Groundwater Application Review Summary Form

Application # G- 18418

PUBLIC INTEREST REVIEW FOR GROUNDWATER APPLICATIONS

A. GENERAL INFORMATION: Applicant's Name: Coleman Koch Properties, LLC, c/o Todd Koch County: Marion

Figure 2. Well Location Map

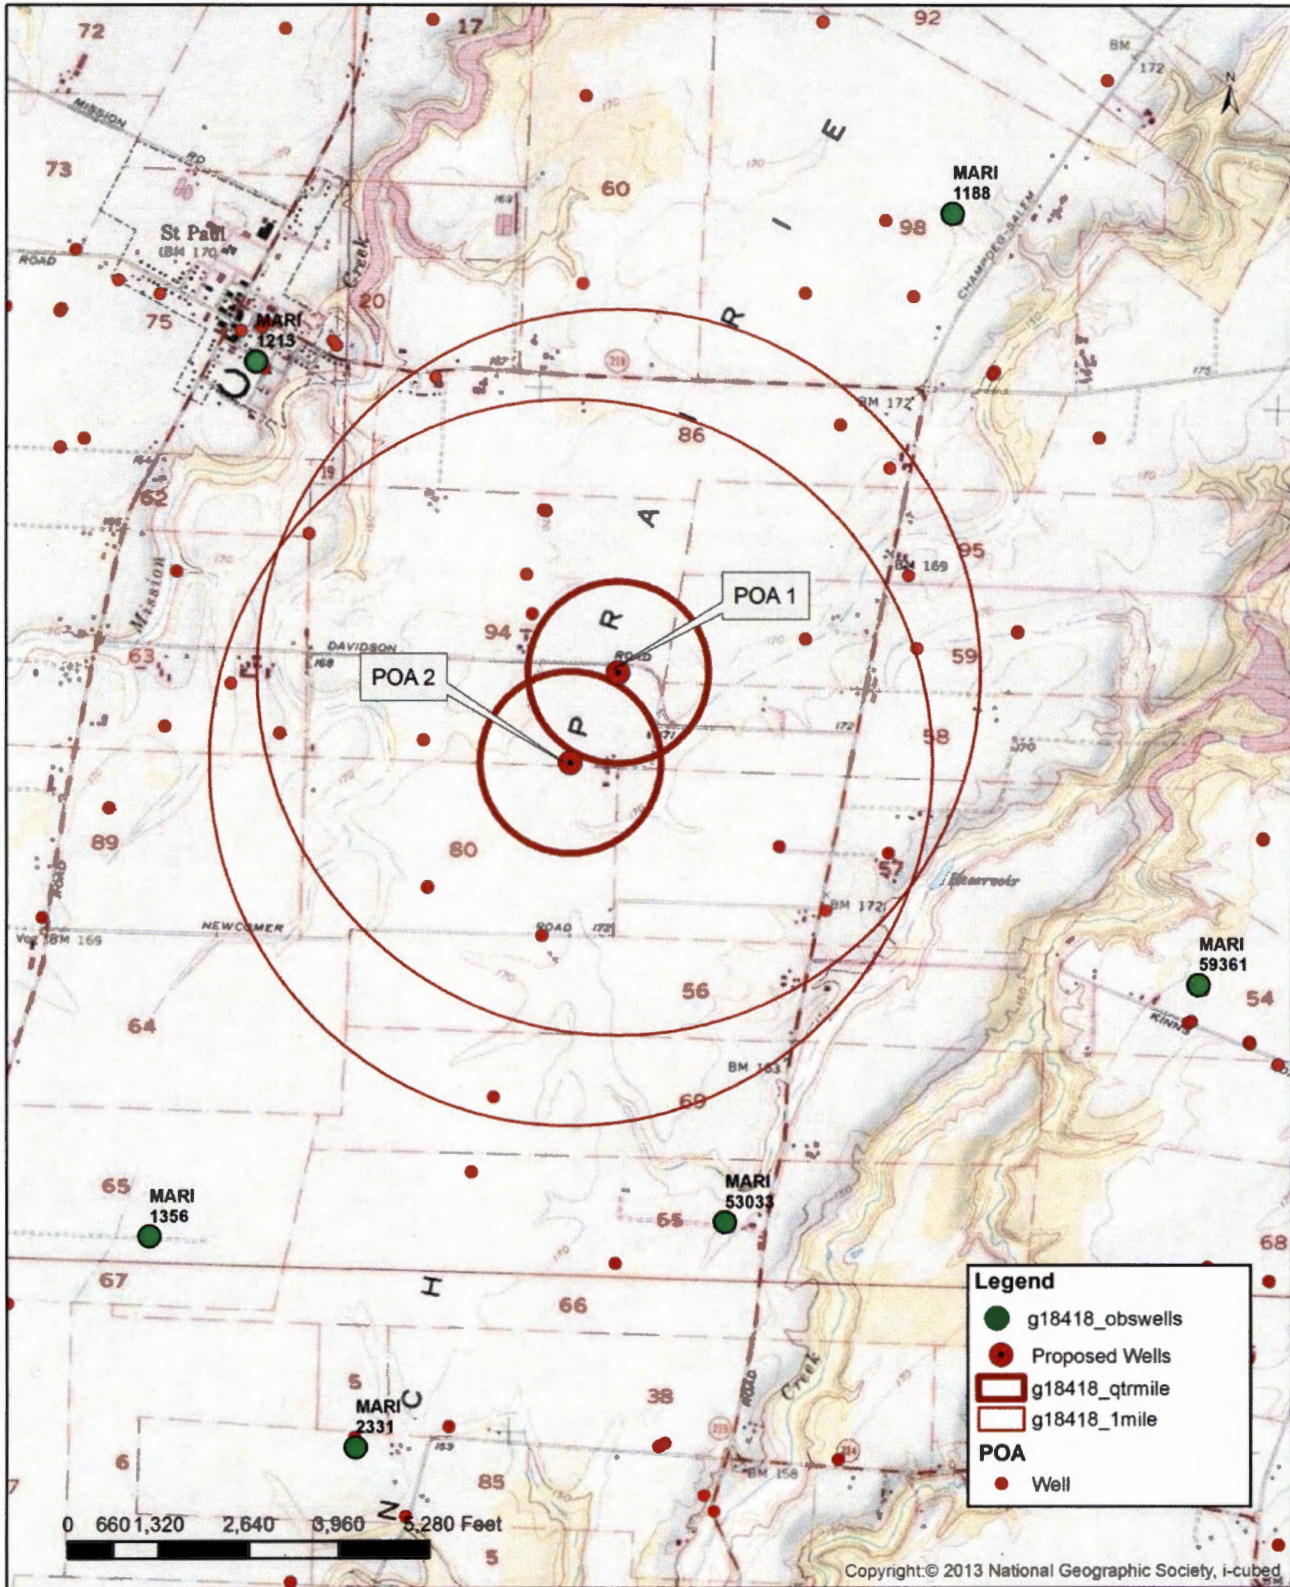
B3. **Groundwater availability remarks:** The proposed wells are located on a terrace about 70 feet above the floodplain of the Willamette River. The terrace is underlain by a thick sequence of fine-grained sediments that extends to depths of approximately 1000 feet. The bulk of the sediments are clays and silts that encase a few relatively-thin beds of sand and gravel that do not appear to be continuous over widespread areas. The upper 60-80 feet of sediments are a sequence of graded beds of fine sand, silt, and clay (the Willamette Silt) deposited by a series of Pleistocene glacial floods which inundated the Willamette Valley. The water table occurs at shallow depths within the Willamette Silt, which acts as a leaky confining layer for productive sands and gravel at depth. Thin zones of sands and gravels below 100 ft bgsd are likely the primary water bearing units. The thin, discontinuous geometry and confined conditions suggest that the aquifer system could be vulnerable to long term drawdown and/or interference.

Figure 3. Water-Level Trends in Nearby Wells

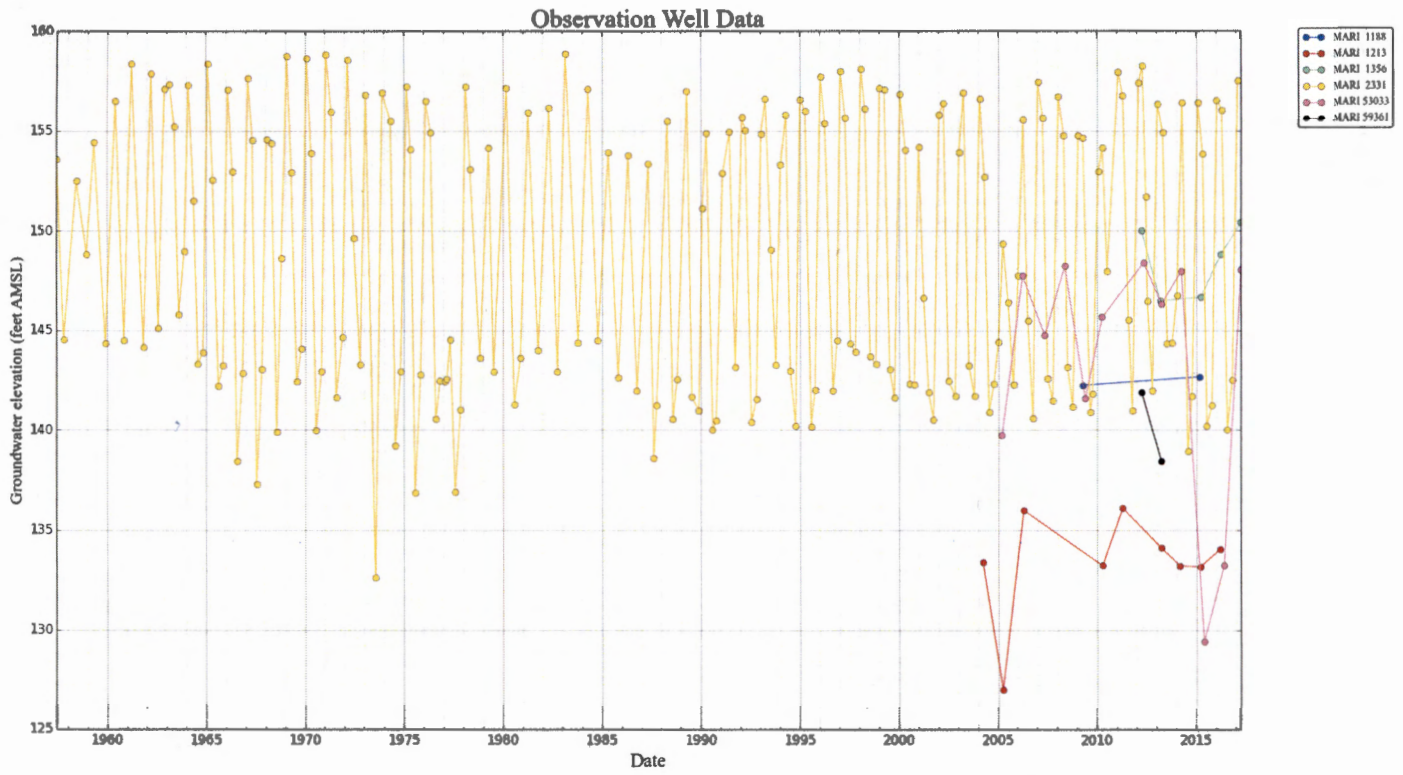
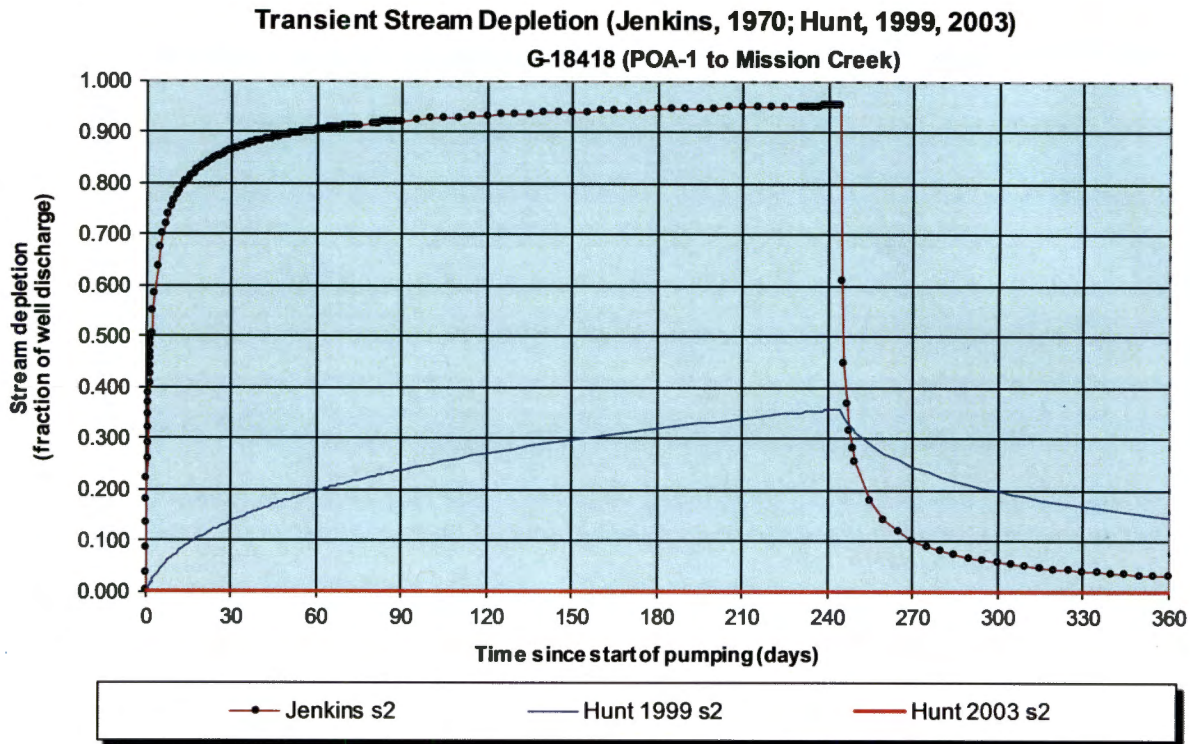
Water level data from state observation well MARI 2331 indicates seasonal fluctuations of about 20 feet, but relatively stable conditions over the last 50 years for shallow wells (see hydrograph in Fig. 3). Long term data is sparse in the deeper water bearing zones which this application proposes to develop, but recent trends indicate water levels are stable (see MARI 53033 & MARI 1213). The thin, lenticular geometry of those zones and the large proposed rate indicate that water-use reporting and water-level measurement conditions are prudent. (Conlon and others, 2005; Gannett and Caldwell, 1998; Swanson and others, 1993).
